SERVICE INFO – INA 0046

Visual differences between the tensioner pulleys for VAG

Image 1: Improved race coating – item no. 531 0524 30 shown here as an example

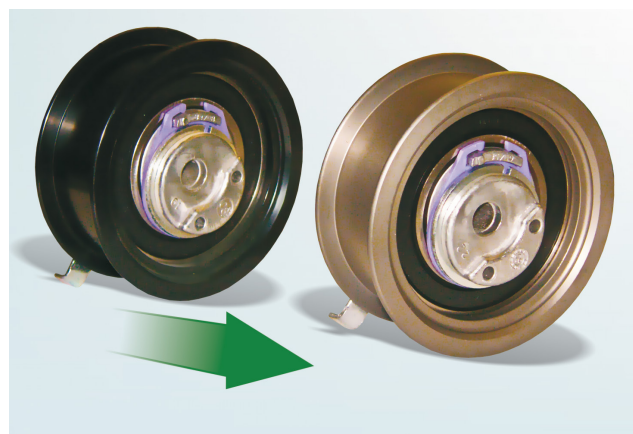
As part of our continuous efforts to improve our products, the coating of the drive wheels on the specified tensioner pulleys has been modified.

The new surface is more durable than the old design.

During the transitional phase, we may have mixed stocks of both designs. Both versions fulfil the relevant technical specifications and can be used without restrictions.
